**ElectraNet Revenue Determination:
Technical Review**

**Advice on Forecast Capital and
Operational Expenditure,
Contingent Projects and
Performance Scheme Parameters**

**Report to
Australian Energy Regulator**

30th October 2012

Figure 1: Current RCP demand forecast and actual demand (ETSA connection points)

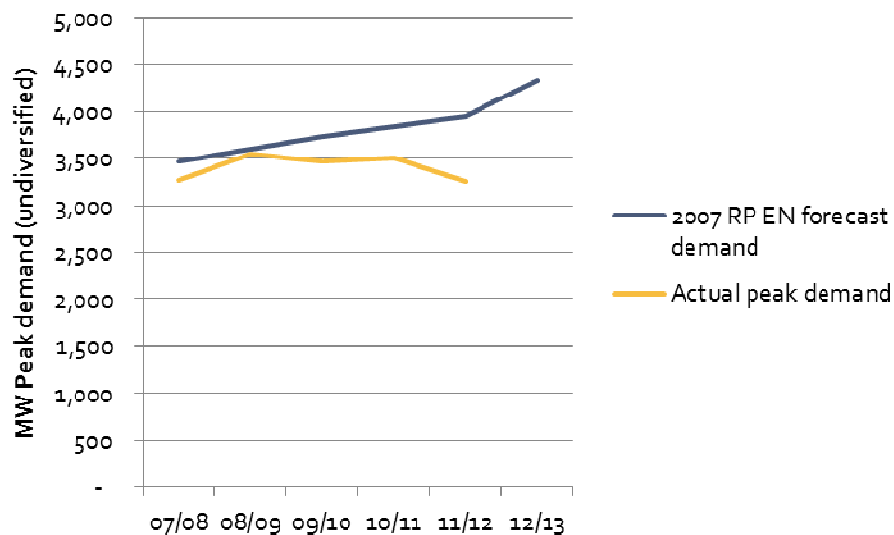
69. ElectraNet's demand has been somewhat lower than was forecast in its 2007 RP, in spite of the year 2008/09 being what was described to us as a record heat-wave, and ElectraNet's all-time highest demand being reached in 2010/11. While recognising that a temperature-related "probability of exceedance" margin is implicit in ElectraNet's forecast for capex planning purposes, the difference in the outturn of demand is evident and we would expect this to have led to deferral of some previously proposed augmentation and connection point expansion capex.

Figure 2: Current RCP capex – Cumulative as incurred/forecast (compared with AER Decision)

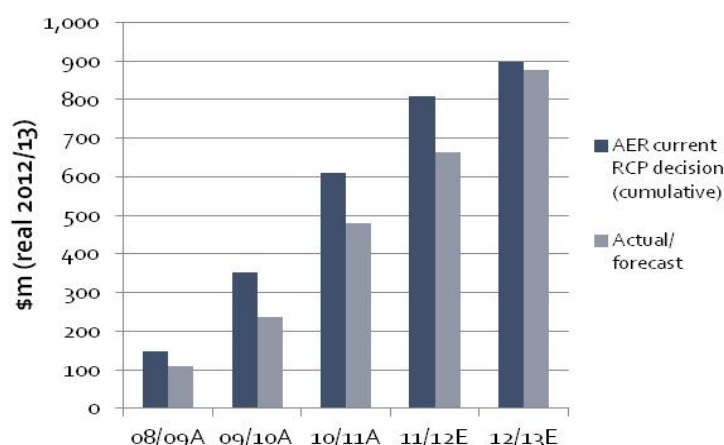
78. Figure 2, below, shows cumulative capex over the period, and shows how ElectraNet estimates that the lower spend initially will be completely absorbed by the higher spend in the final year.

Figure 6: Components of opex in current RCP

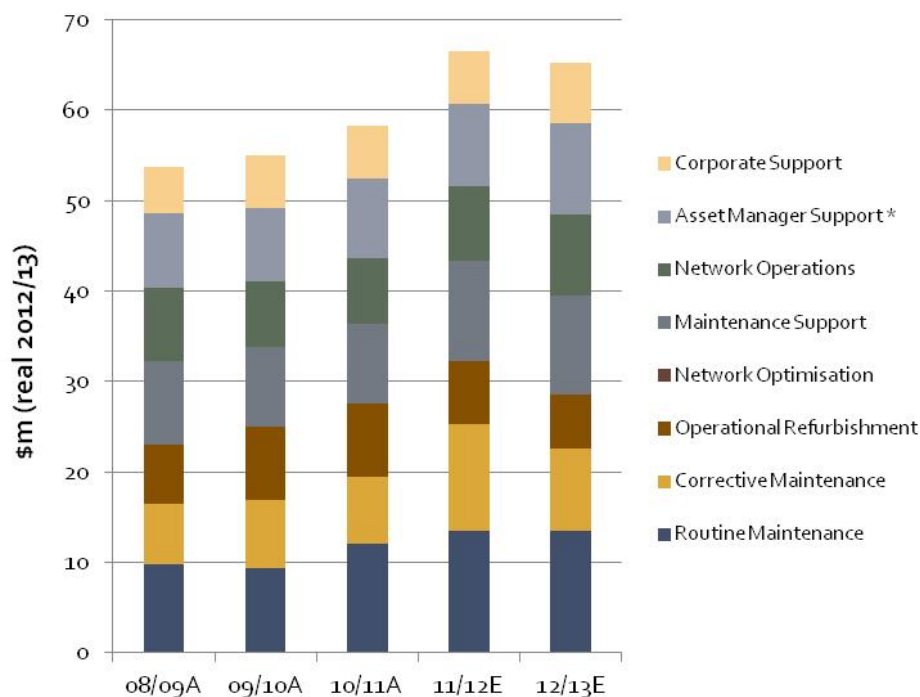
- 90. As figure 6 shows below, there was a step increase in routine maintenance costs in 2010/11 and a significant increase in corrective maintenance costs in 2011/12. Corrective maintenance costs were subsequently reduced in 2012/13 but this reduction was largely offset by increases in network operations, asset manager support and maintenance support.

Figure 17: Expenditure by current project phases

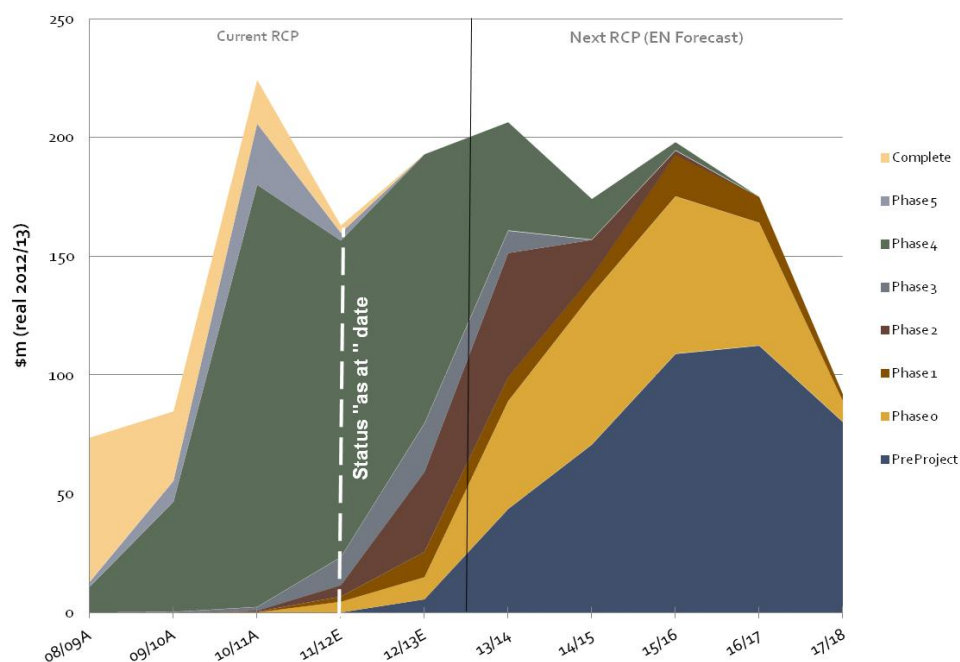
163. ElectraNet has confirmed that the PMM incorporates, the fundamentals of the industry standard Project Management Body of Knowledge (PMBOK) published by the Project Management Institute. On this basis and on observation of the PMM operating in practice we consider that PMM is appropriate for an asset based infrastructure business such as ElectraNet.
164. Figure as below shows the Phase status of network capex projects over the current and next RCP.

Figure 24: Replacement capex excl water pumping station projects

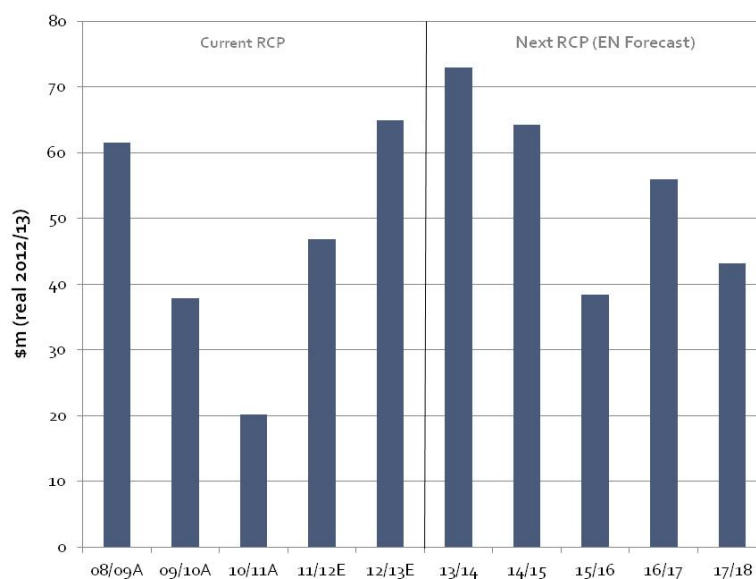
203. The increase in underlying replacement capex for the next RCP is 18.8% above the current RCP (actual and forecast).
204. In figure 24, the replacement capex excluding water pumping station supplies reveals a much more variable profile. The underlying replacement capex profile shows replacement capex at relatively high levels in the first two years of the RCP with reduced levels in the last three years.

395. The relatively high number of projects that are only at the early stages of the PMM phases raises concerns. When this is considered alongside the underlying replacement capex profile seen in figure 24, and which is front-loaded, it is considered probable that the actual expenditure profile will move to be more end-loaded. This result would be consistent with what happened in the current RCP where expenditure profile can be seen to be end loaded despite being forecast to be front loaded.
396. We have taken the likelihood of potential expenditure deferral benefits within the RCP into account when considering an appropriate level for the prudency adjustment for replacement and refurbishment capex.
397. We found no reason to conclude that ElectraNet could not deliver the forecast levels of capex and a realistic proportion of contingent projects.

Figure 32: Demand forecast comparison

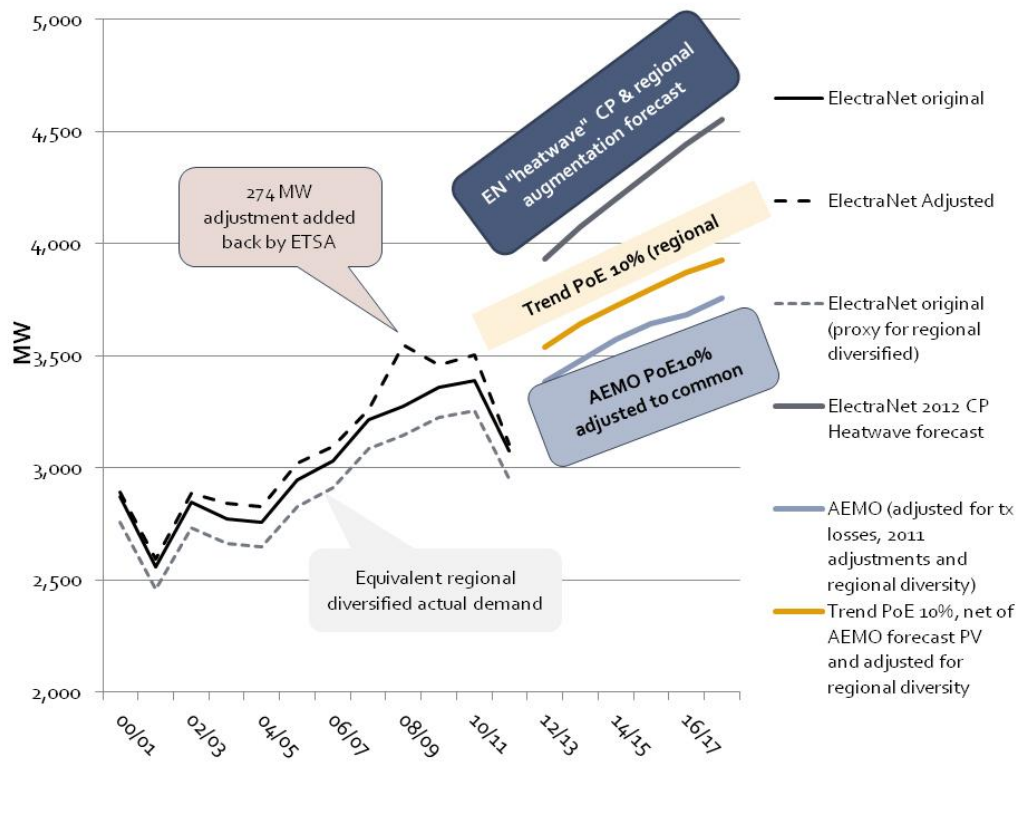
- 316. The figure below compares ElectraNet’s demand forecast with AEMO’s 2012 demand forecast, and shows our trend-line check forecast. The graph also illustrates how the 2008/09 “heatwave peak” referred to by ElectraNet (and which was the basis for ETSA’s demand forecast) was a result of a range of adjustments being “added back” to the actual peak demand. This was not the all-time peak demand, which was somewhat lower, and occurred in 2010/11.

Figure 36: Asset Management Lifecycle with Enhanced Condition-based Maintenance

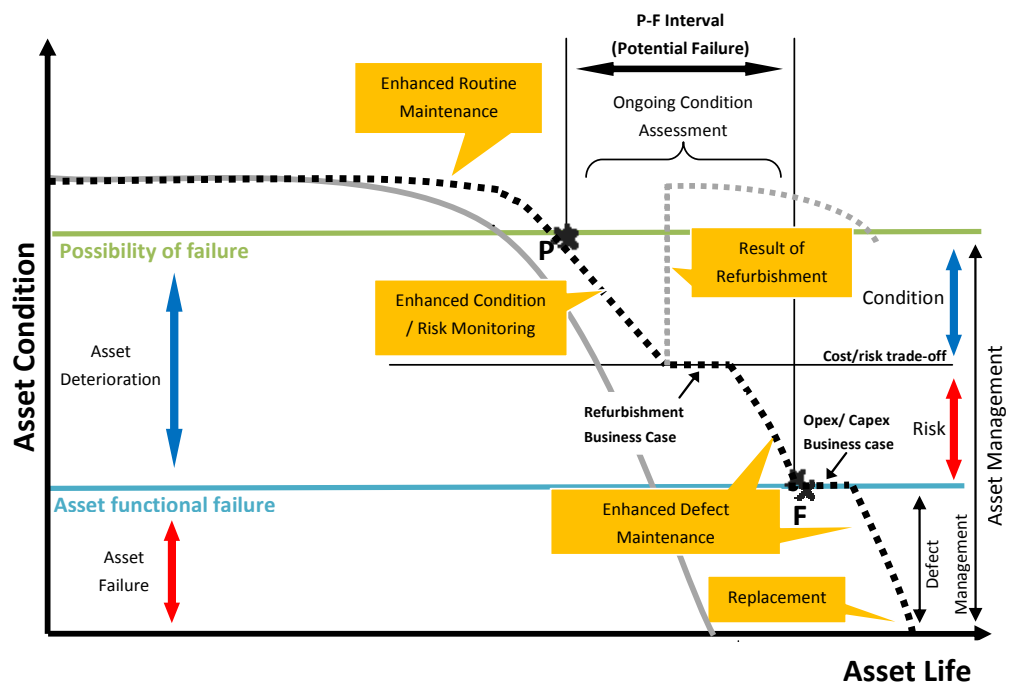
- 349. Figure 36 is a variation of the asset life cycle optimisation curve (PF curve) used by ElectraNet to demonstrate the theory supporting its TALC methodology. The TALC approach establishes the optimum time in an assets life to deploy a specific expenditure strategy (i.e. routine maintenance, operational refurbishment, corrective maintenance and asset replacement). Essentially the application of each expenditure strategy will change the shape of the PF curve. For example, mid-life asset replacement will extend the curve, operational refurbishment will life asset performance at the point of expenditure.

722. We also discussed with ElectraNet our view that there was insufficient evidence of “threshold” analysis of cost/risk and economic trade-offs. For the purpose of illustration, we used figure 36 (section 6.6.4) of the current report.

Figure 52: Not accepted - Within expected demand (no new connection points proposed)

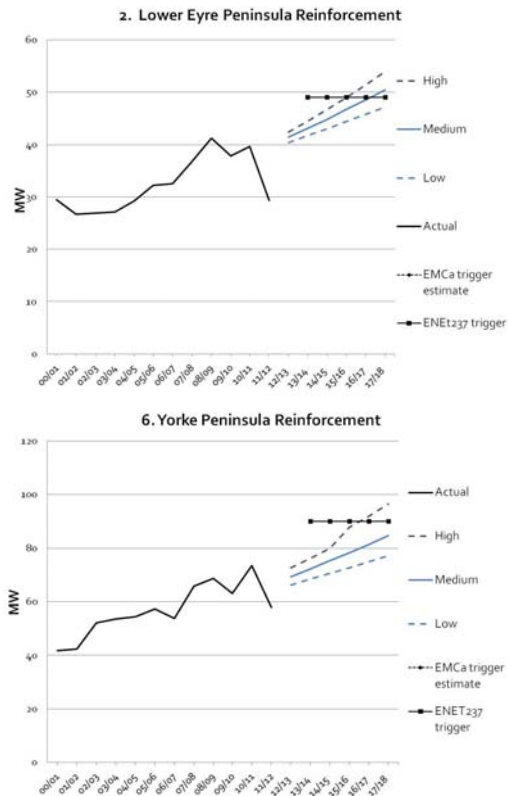
567. For each contingent project proposed with a demand-related trigger, we analysed ElectraNet's forecast demand for the connection point(s) in relation to the proposed trigger. We consider that the Lower Eyre Peninsula Reinforcement and Yorke Peninsula Reinforcement projects should be rejected, as they could be triggered within ElectraNet's expectation of natural demand growth.

753. At the meeting on 3rd October we introduced the concepts that we have applied in grouping the proposed contingent projects for the purpose of our findings (see figure 52 of the current report). Discussion on the rationale for these groupings was continued at a further meeting with ElectraNet in Adelaide on 4th October. At the 4th October meeting we further discussed interpretation of relevant clauses of the NER, and also discussed our understanding of the situations presented to us for each contingent project and the proposed triggers. We sought to confirm that we had a correct understanding of the nature and drivers of the proposed projects, of ElectraNet's reasoning for presenting them as contingent projects and for its proposed trigger definitions.

Figure 53: Not accepted - Within expected demand (new connection points proposed)

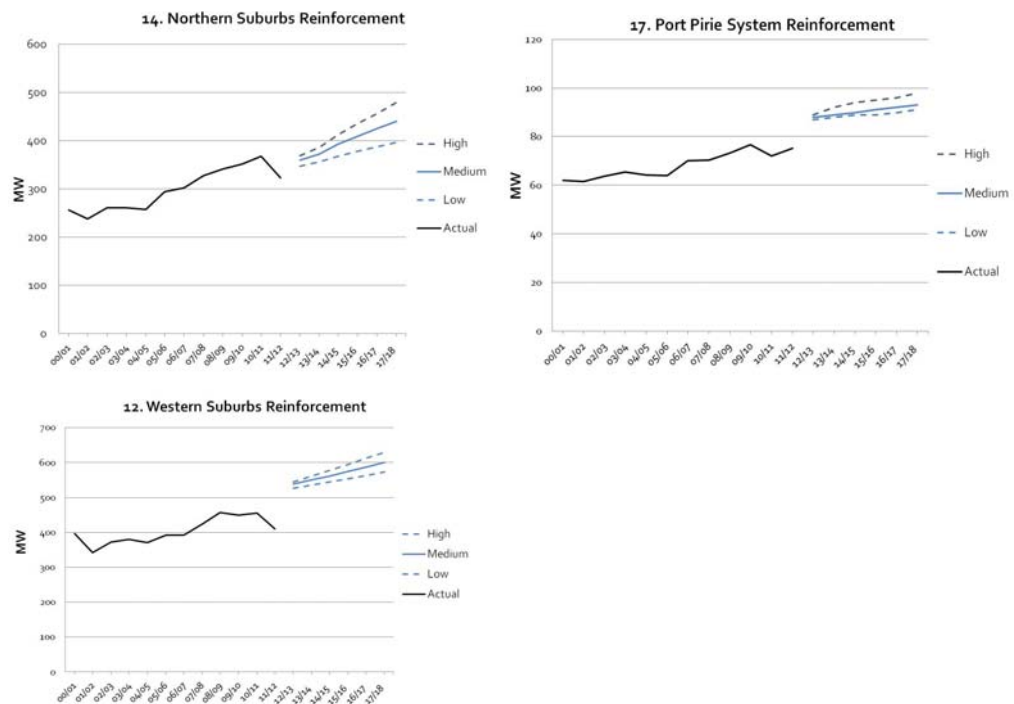
569. The following three projects were proposed with the primary trigger being a request for a new connection point. It can be seen that ElectraNet's demand forecast range for each connection point is essentially a trend growth forecast and no evidence of a step demand increase was provided to us. We propose rejecting one further project, Fleurieu Peninsula, on the same grounds, noting that, while a demand forecast was not provided for this area, ElectraNet's commentary indicates that ETSA's demand forecast takes account of any step load increases on the distribution side and no evidence of further step load increases was provided.
